Perry Nuclear Power Plant  
Docket No. 50-440  
Response to Request for Additional Information Related to a License Amendment  
Requesting a Power Uprate (TAC No. MA6459)

## Perry Nuclear Power Plant Responses to an NRC Request For Additional Information (RAI) Forwarded by Electrical Section of the Electrical and Instrumentation and Controls Systems Branch

## Perry Nuclear Power Plant Responses to an NRC Request For Additional Information (RAI) Forwarded by Reactor Systems Branch

# Perry 105% Power Uprate Two Loop Operation

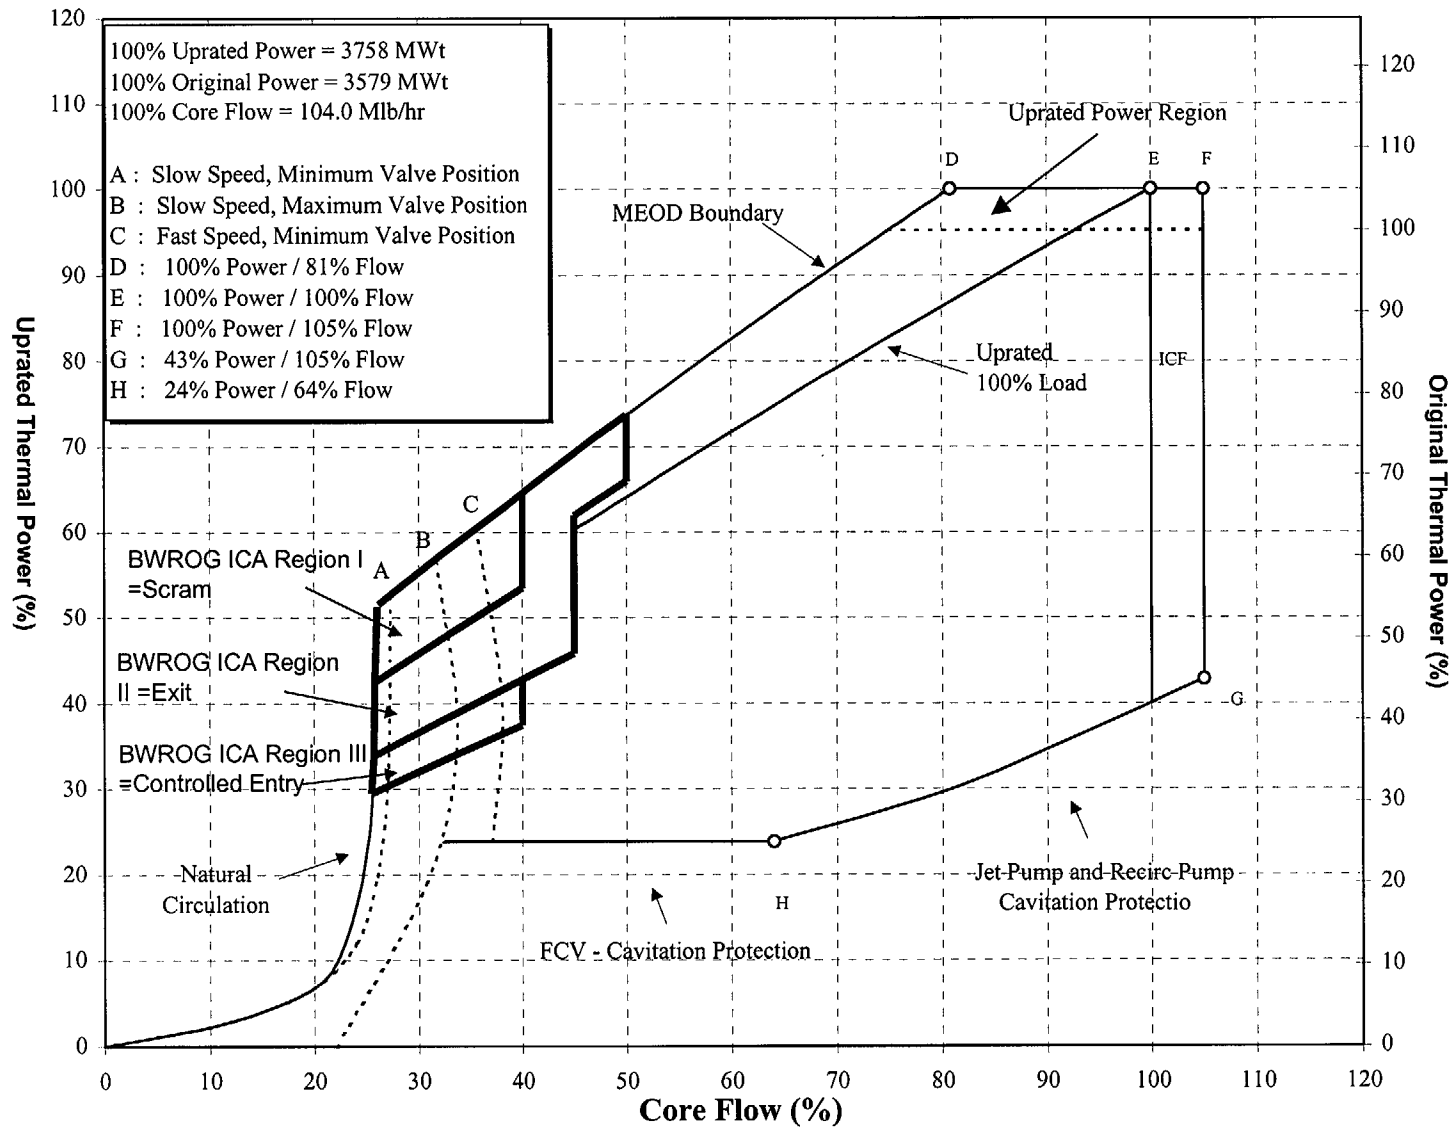
2. Explain how the maximum extended operating domain and 100-percent rod lines were determined on the proposed power-to-flow map. A figure giving the power-to-flow map with both the current and proposed power scales would be helpful for comparison.

3. Provide power-to-flow maps showing the current stability control regions and the regions under power uprate conditions. Explain any differences with the interim corrective actions defined in GE SIL 380 and discussed NRC Bulletin 88-07 Supplement 1.

The power uprate Maximum Extended Operating Domain (MEOD) line is just the pre-uprate MEOD line extended to 105% power and rescaled. The power uprate values (MWt vs. %Core Flow) below the original 100% MWt do not change. The pre-uprate 100% rod-line is the current 105% rod-line extended to 105% power and rescaled.

Figure 2-1, Perry 105% Power Uprate Two Loop Operation (TLO) Reactor Operating Domain from NEDE-32907P, "Safety Analysis Report for Perry 5% Thermal Power Uprate," (Attachment 1 of the power uprate license amendment request) is included (see page 8 of this RAI response). This Figure has a second Y-axis added to the left hand side in addition to the original (current) thermal power % on the same map.

Figure 2-1, Perry 105% Power Uprate TLO Reactor Operating Domain from NEDE-32907P (Attachment 1 of the power uprate license amendment request) is attached (see Page 8 of this RAI Response) with the Boiling Water Reactor Owners Group (BWROG) Interim Corrective Actions (ICA) regions illustrated. The Perry Plant modified operating procedures and operator training are consistent with, or more conservative than the BWROG guidelines as detailed in the response to Generic Letter 94-02, "Long-Term Solutions And Upgrade Of Interim Operating Recommendations For Thermal- Hydraulic Instabilities In Boiling Water Reactors", reference letter PY-CEI/NRR-1855L, dated September 4, 1994.

The regions have been rescaled to maintain the same absolute power and flow on the region boundaries as would exist for the revised ICAs prior to power uprate. In units of MWt, there is no change to the regions for power uprate conditions.
